**Re: City of Coos Bay Land Use Application #187-18-000153  
Concurrent Land Use Applications by Jordan Cove Energy Project L.P.  
Coos Bay Estuary Navigation Reliability Improvements  
Comments of Oregon Shores Conservation Coalition – Rebuttal Evidence**

Document Title	Pages
Oregon Dep’t of Env’tl. Quality (“DEQ”), <u>Jordan Cove 401 Water Quality Certification Decision Cover Letter</u> , (May 6, 2019)	4
DEQ, <u>Evaluation and Findings Report: Section 401 Water Quality Certification for the Jordan Cove Energy Project</u> , (May 2019)	209
Oregon Shores, Second Open Record Period Comment for Coos County NRIs	12
Substantive Comments of Sarah Reif, ODFW on DSL Removal-Fill Permit Application No. 60697-RF, (Feb. 2, 2019)	45

Department of Environmental Quality

May 6, 2019

Figure 16: Pipeline Crossing at Tributary to Cooston Channel showing no “neckdown” of ROW

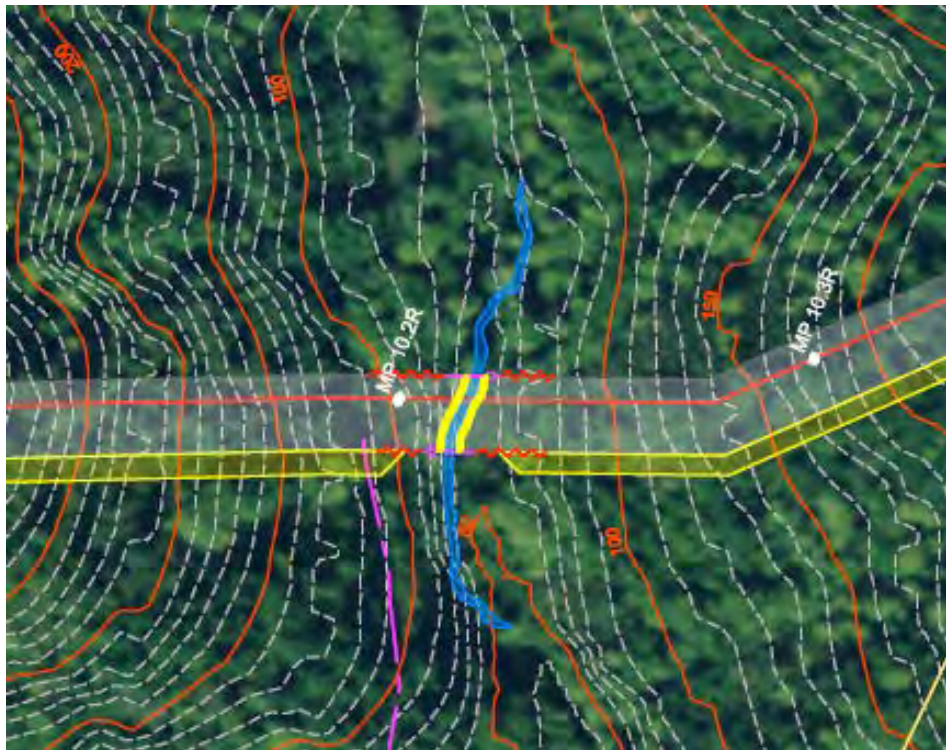
As an illustration of the reasons for DEQ's concerns about the temperature impacts of the proposed Project, at pipeline stream crossing at Milepost 58.78, Ollala Creek is limited for temperature year round and is under an approved TMDL. Similarly, DEQ has placed Rice Creek (Milepost 65.76), South Umpqua River (Milepost 71.27), North Myrtle Creek (Milepost 79.12), South Myrtle Creek (Milepost 81.19), and many others on the 303(d) list for temperature. These streams are under an approved temperature TMDL.

Figure 17: Modeled Turbidity from Capital and Maintenance Dredging at NRI-3

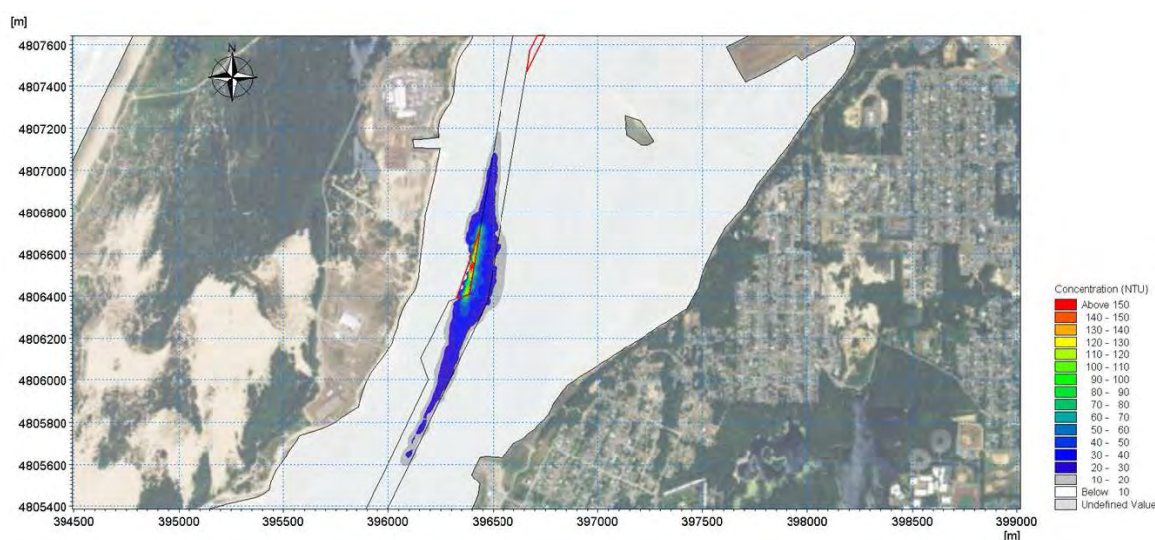
In addition, JCEP modeled the effects of turbidity at each of the proposed dredging locations using clamshell, hydraulic suction dredging, and excavation methods.<sup>94</sup> The modeling confirmed turbidity exceeding 10 NTU above background levels extending a total of more than one mile above and below the Navigational Reliability Improvement dredge locations. The modeling also confirmed elevated but comparatively localized turbidity plumes at the Slip, Access Channel, and eelgrass mitigation dredge locations. The report recommends that both capital and maintenance dredging operations incorporate construction BMPs, although the “nature and extent of BMPs should be determined through coordination with the regulatory agencies”.

Location of TAR 27.06 near Milepost 27 on the General Location Maps. Drawing No. 3430.31-Y-Map 5, Sheet 6 of 55

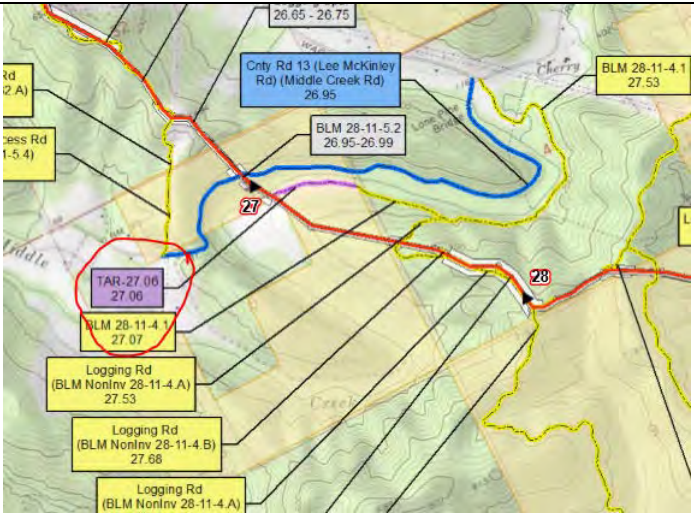
Location of TAR 27.06 near Milepost 27 on the Geologic Hazards Maps. Figure 8 of 47. **Note:** the light brown areas are Potential Rapidly Moving Landslide Hazard

Location of PAR-113.66 and the reconstruction of BLM Noninv 32-2-36.A. Drawing No. 340.31-Y-Map 14, Sheet 32, 55

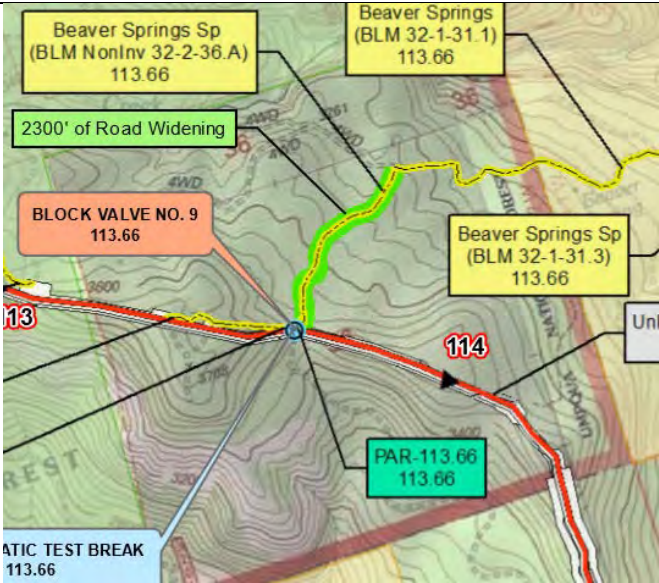
PCGP is proposing to site another proposed new road labeled as PAR-132.66 and shown in the map excerpt below. PCGP proposes to locate this PAR in a Potential Rapidly Moving Landslide Hazard Area. This proposed PAR is also near landslides identified from Aerial Photos and from LiDAR. Moreover, PCGP is proposing to reconstruct BLM’s Beaver Springs road (BLM Noninv 32-2-36.A) by widening it. According to PCGP’s Geologic Hazard Map, this BLM road identified for widening is located above a landslide area that drains to intermittent stream discharging into Dead Horse Creek. PCGP has not provided DEQ with design information regarding the need for the creation of fill slopes for this proposed new road in an area with unstable slopes. PCGP has not provided DEQ with design information for the reconstruction of the BLM road above unstable slopes. Has PCGP conducted a geotechnical investigation of this road-widening project? If performed, does this geotechnical investigation indicate the need for reinforced fill for this road-widening project? Where will PCGP discharge the post-construction stormwater for this PAR? Given the lack of design details, these questions surface for DEQ while reviewing PCGP’s submittal.

Geologic Hazard Map (Figure 24 of 47) from Resource Report 6 featuring several identified landslides including 34, 37, and 42 discussed

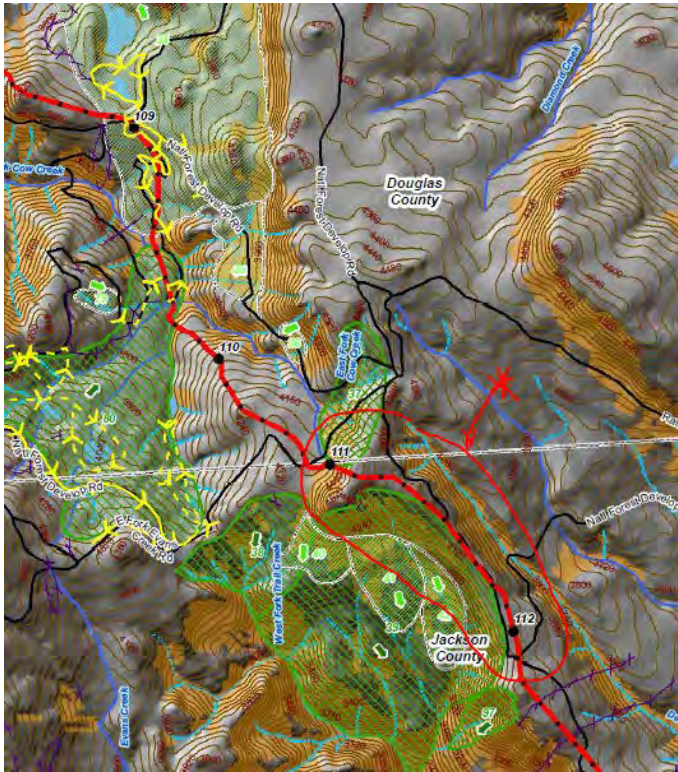
As documented in DEQ’s review above, water plays a key role in the cause and mitigation of landslides. Referring to the map excerpt below, PCGP has not provided DEQ with information on how it will manage stormwater to avoid causing a debris flow below the pipeline in the rapidly moving landslide hazards on each side of the pipeline from Mile Post 111 to Mile Post 112.2. These Areas of RML also coincide with Landslides 37, 38, 42, and 80. Landslide 37, 38, 42, and 80. These are identified landslides from aerial photos. However, PCGP did not include them as part of its field evaluations of landslide risks. PCGP has not provided DEQ with engineering designs to stabilize the proposed pipeline’s fill slopes for Landslides 37 and 42 as well as the cut and fill slopes for Landslide 38 and 80. There are numerous other areas of landslide risks where PCGP has provided no field evaluations or engineering analysis for protecting water quality from debris flows potentially precipitated by:

- Loading additional stormwater at the top of unstable slopes when constructing and operating the gas pipeline.
- Cutting into an unstable slope when constructing and operating the gas pipeline.
